To: Kristopher Byrd, Well Construction and Compliance Section Manager
From: Travis Kelly, Well Construction Program Coordinator
Subject: Review of Water Right Application G-18931
Date: July 28, 2020

Application # G- 18931

TO: Water Rights Section Date 7/24/2020
 FROM: Groundwater Section Joe Kemper
Reviewer's Name
 SUBJECT: Application G- 18931 Supersedes review of na
Date of Review(s)

Water-Level Trends in Nearby Wells

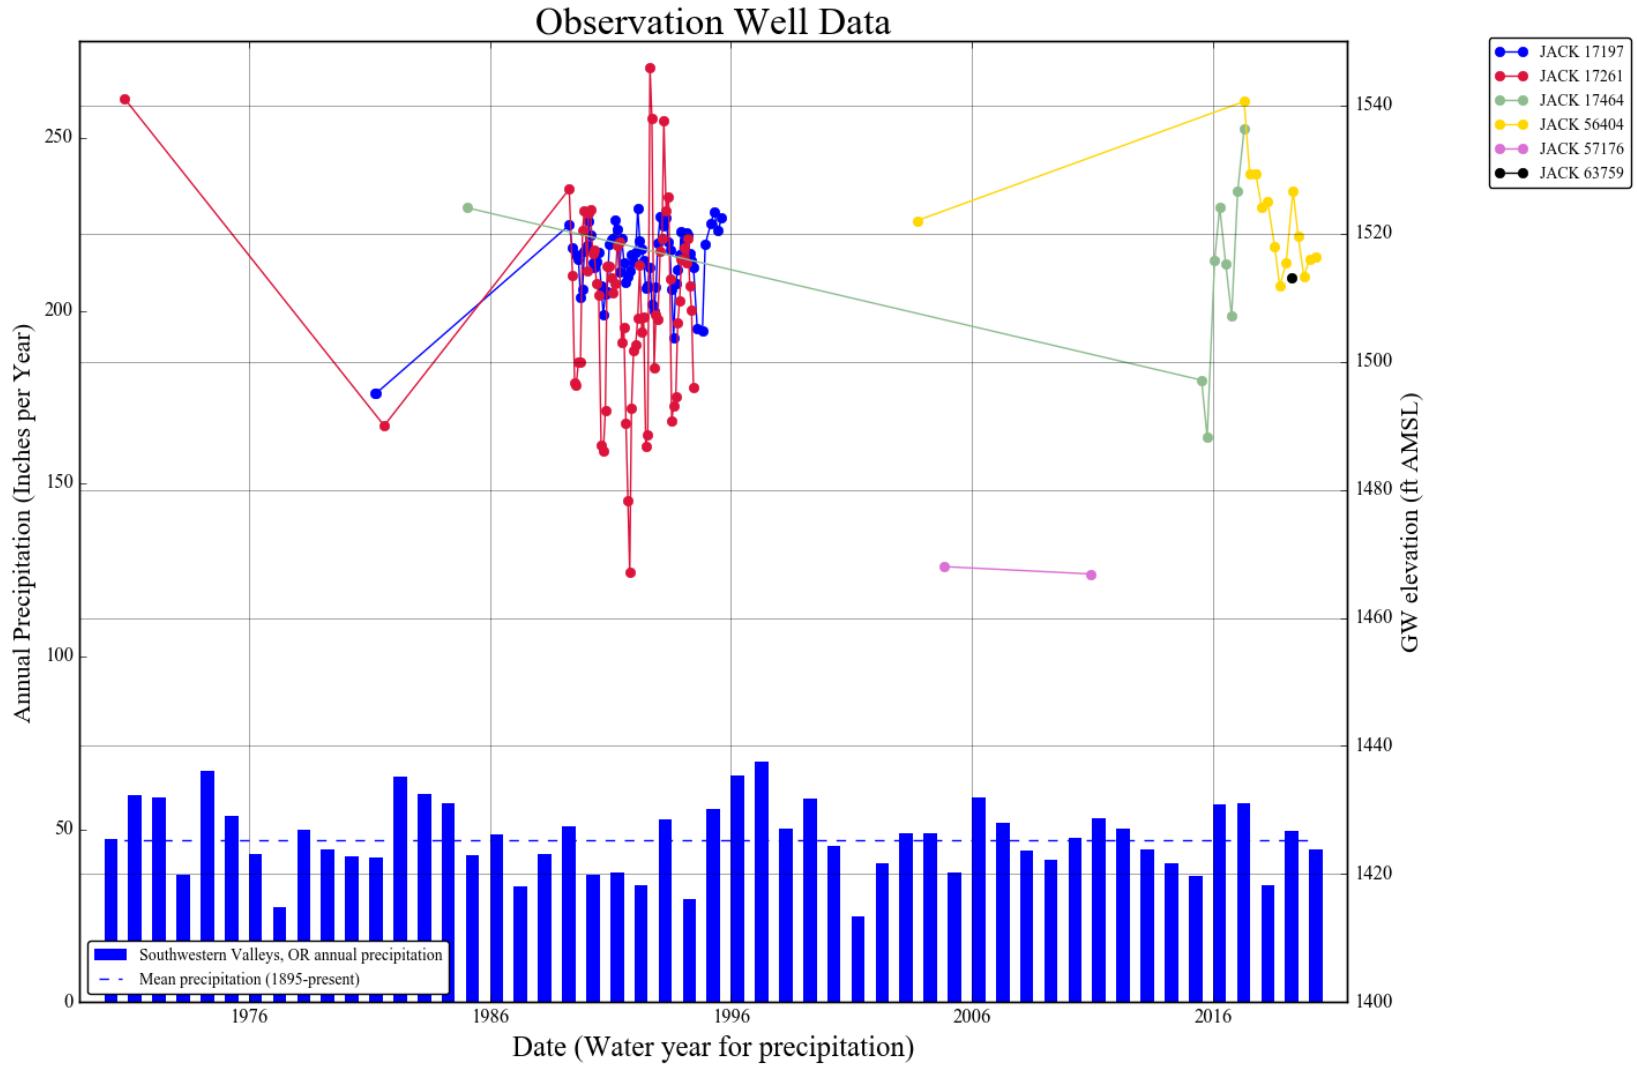
B3. **Groundwater availability remarks:** The applicant’s well accesses groundwater hosted in fractured bedrock of the Western Hayfork terrane. Bedrock at this site is overlain by ~50 feet of unconsolidated terrace sediments, which do not appear to be a source of water. Well yields in TRS 38S/3W-S27 are low (median = 10 gpm), and yields typically decrease with depths beyond 200-300 feet, both of which are typical for the fractured bedrock aquifers in the area. Water level trends in adjacent OWRD observation wells indicate that aquifer levels respond to both seasonal precipitation and year-to-year precipitation variation. Water level records do not span a long enough time period to conclude that the resource is or is not over appropriated.

Theis (1935) Distance Drawdown Modeling Parameters and Results

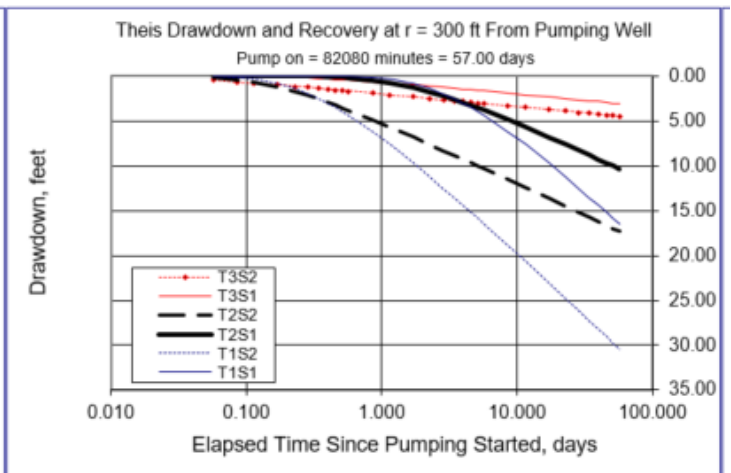
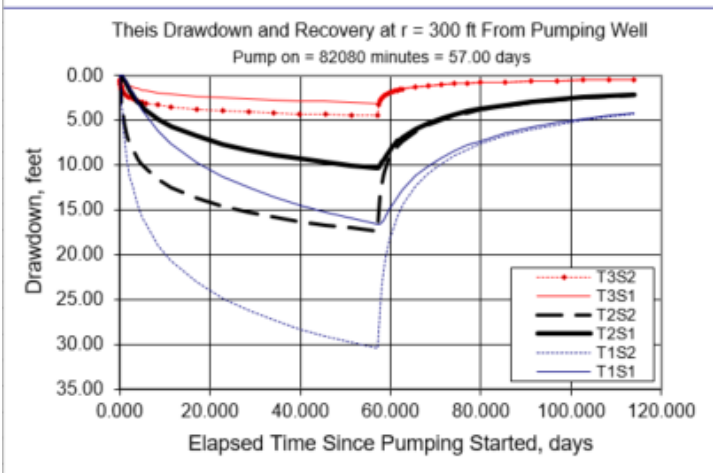
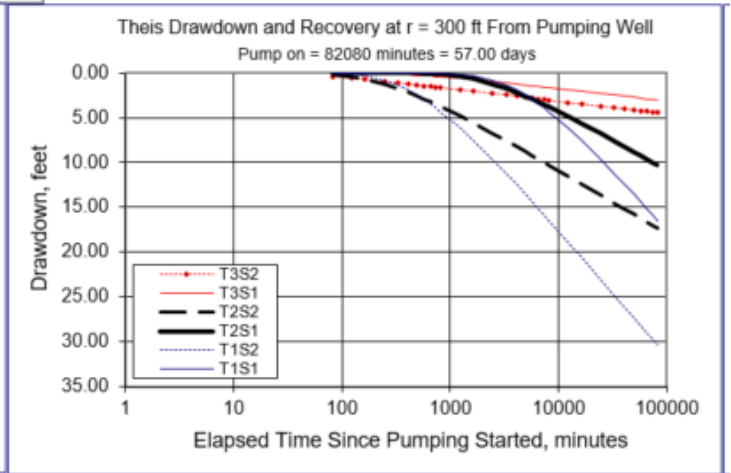
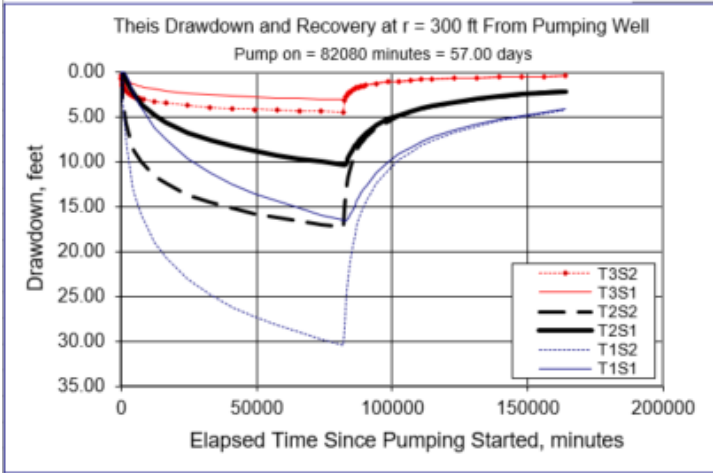
This area has relatively high groundwater development; there are ~150 well logs filed in section 27 and 11 groundwater POAs within a mile of the applicant’s well. The Theis equation (1935) is used to estimate maximum well-to-well interference from the proposed use (5 AF total at 20 gpm for 56.6 days to the nearest tax lot, ~300 feet). The resulting drawdown is expected to be less than 10-15 feet. Water use, static water level, and interference conditions should be applied.
